Responses to Questions from Committee to FOS (Jim Malkin Letter – 11/5/2015)

Explanation for access route change

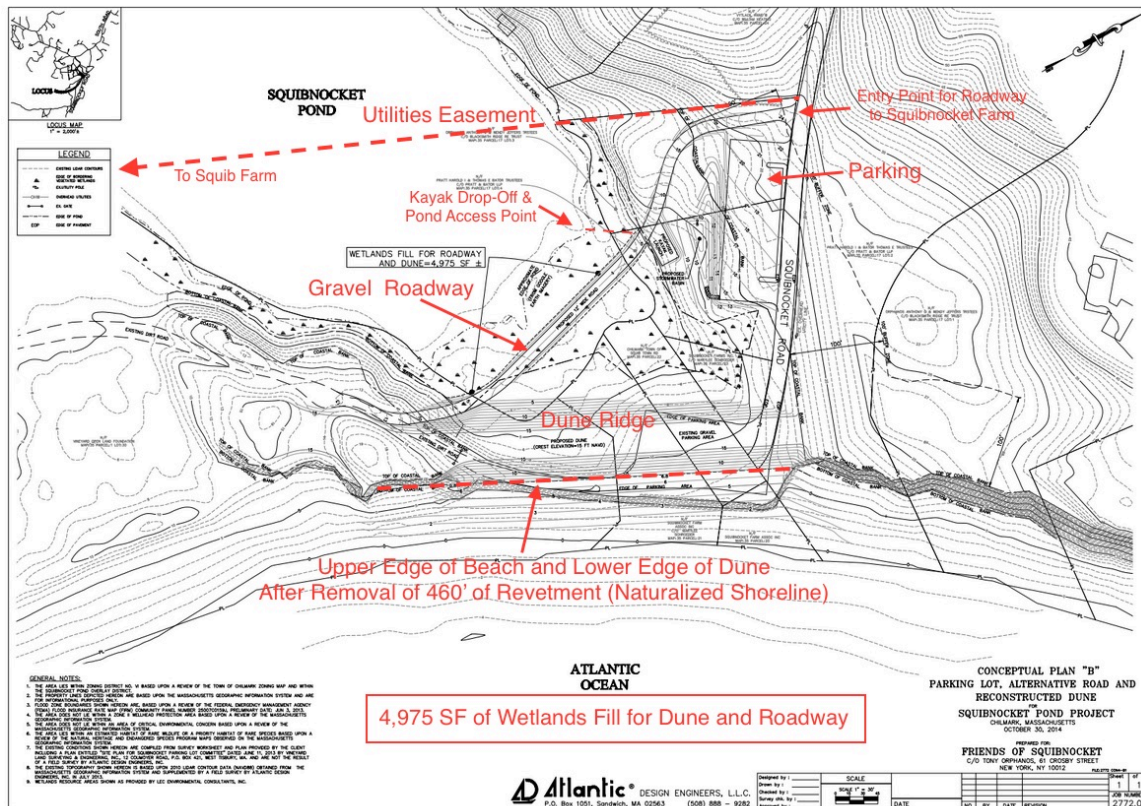
(‘Please provide an explanation for the access route change from the backside of the proposed dune ridge to the edge of the pond as provided in your Oct 24 letter.’)

Improved maintainability: After several meetings with different groups, our engineering team decided that the roadway on the backside of the dune ridge could be improved upon. Moving the road back toward the pond provides an independent route from the dune, which is a better for minimizing the effects of overwash on the roadway and for handling the effects of erosion.

The illustration below shows the oblique angle of the road to the shoreline (as opposed to the roadway running parallel to the shoreline behind the dune). This is a more stable roadway because there will be many more years of erosion-free use.

Note the wetlands fill has been increased to 4,975 SF but remains below the allowable 5000 SF for a 'limited project'. The trade-off is better security and maintainability. The height of the dune has been lowered by about a foot and a half, to 15'. This will reduce the quantity of material required for first build and it will increase the supply of sediment to the backside of the dune as a result of over-wash, which is both natural and healthy and required for dune & road migration.

Impact on parking & public safety: The goal is for pedestrians to have a clear access to the beach on a road or a path that does not require crossing the road to Squibnocket Farm. With the new route, the traffic to Squibnocket Farm turns off above the parking lot and is routed behind it, making the path to the beach far safer. The best public safety solution is to run the road behind the proposed parking lot, closer to the pond.
